A103 Memorandum

Date:	8 August 2019			
Project Name:	Newcastle Courthouse Redevelopment Nihon University			
Project No:	auncl-17-0347			
Reference:	17-0347 memo 27 – 08.08.2019			
Page	1 of 6			
To:	Copy	Company	Attention	Circulation
✓		NSW Department of Planning & Environment	Megan Fu	Megan.Fu@planning.nsw.gov.au
	✓	City Plan	Murray Blackburn-Smith	murraybs@cityplan.com.au
	✓	Azusa Sekkei Co Ltd	Jun Yokobori	yokobori1482@azusasekkei.co.jp
	✓	dwp Australia Pty Ltd	Ed Clode	edward.c@dwp.com
	✓	dwp Australia Pty Ltd	Katherine Daunt	Katherine.d@dwp.com

27 SSD-9787 Nihon University Newcastle Campus – National Trust and Heritage Council Response

Extract from LP05_Rev C:

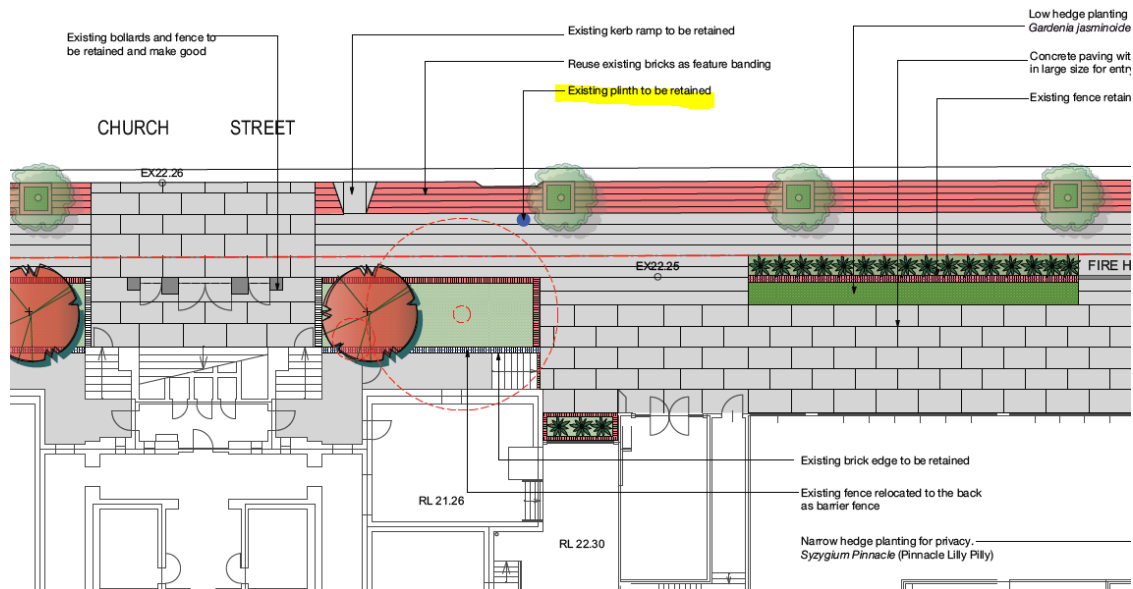
The 'stone plinth' is one of several 'heritage' water bubblers in the The Hill Heritage Conservation Area and should be made operable and retained in situ for public amenity at the Bolton-Church Street intersection instead of relocated to a courtyard.

The existing "stone plinth" water bubbler is to remain on the footpath in its current location and state of operation. There is no intention for the stone plinth water bubbler to be relocated or altered. Please refer to Landscape drawing LP05_Rev C "LANDSCAPE PLAN - 1ST FLOOR" where it clearly notes on this drawing that the plinth is retained.
